FDI	ENGINEERING CHANGE ORDER		ECO NO: 15-021
			Page 1 of 3
TITLE	DWG NO.	CURRENT REV	NEW REV
uEZGUI-4088-43WQN	uEZGUI-4088-43WQN-BA	1.3	2

DESCRIPTION OF CHANGE:

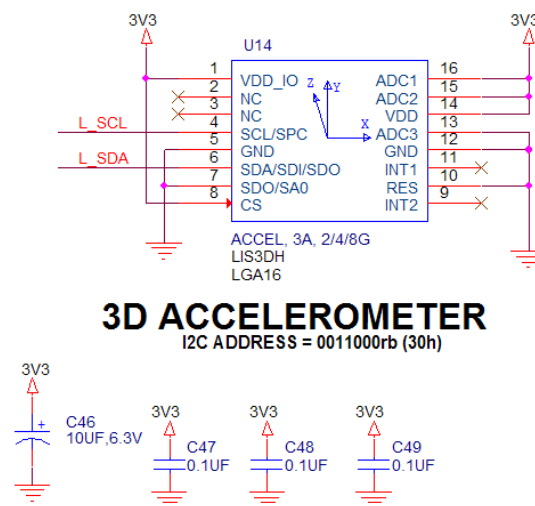
1. Change accelerometer part (U14) from MMA7455L (FDI PN U500437) to LIS3DH (FDI PN U500639). Below is the change on the schematic:

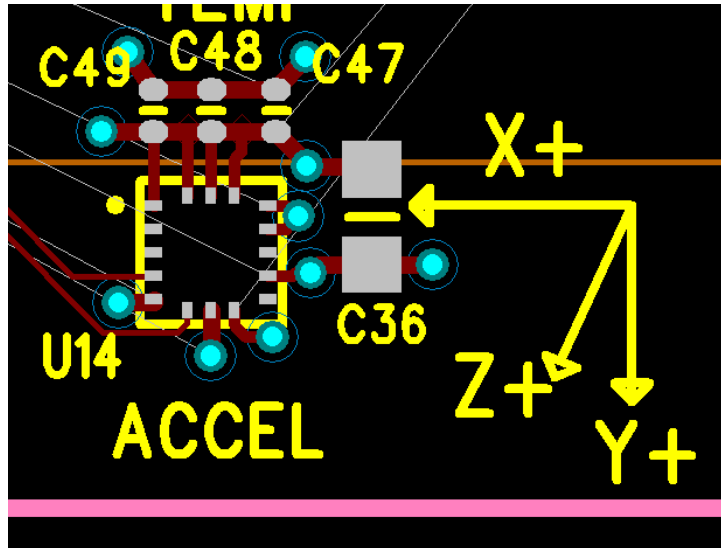
- Adjust accelerometer directional symbol to match software implementation. The new component and symbol are shown below:

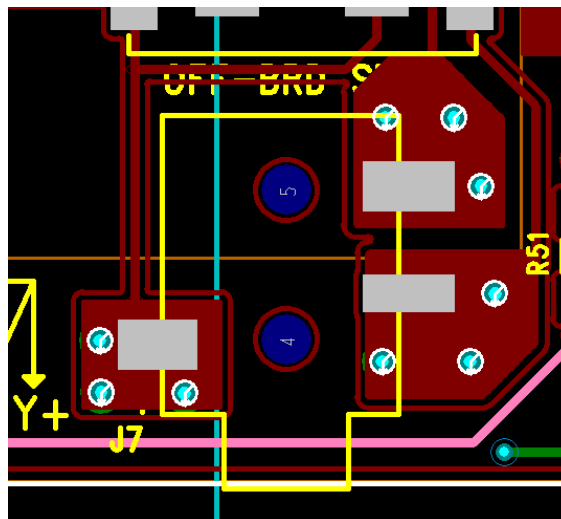
- Change off board speaker connector (J7) to RDI compatible footprint decal (CON3_RDI_RSJ-3532-3-SMT-MOD). This part's location did not move. See below:

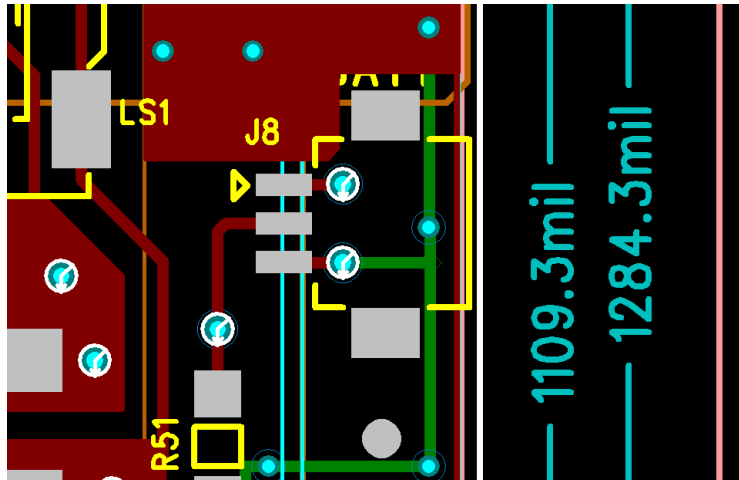
- Adjust off-board Batt connector (J8), bringing the pads inward on the PCB and doing minor rerouting of the connector. The new footprint and routing is shown below:

Recommended Solder Pad:

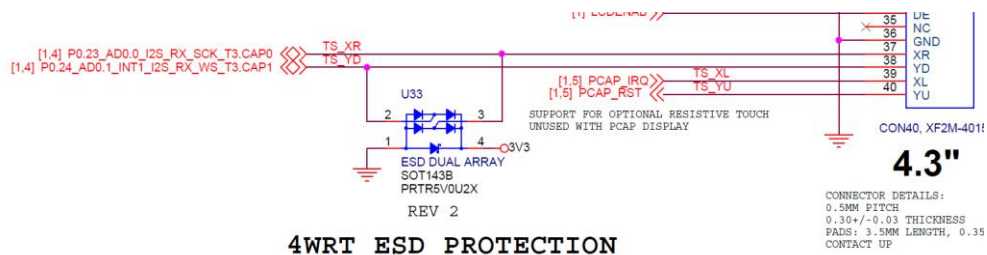
- Adjust PCB footprint for Y1 to match manufactures recommended layout.
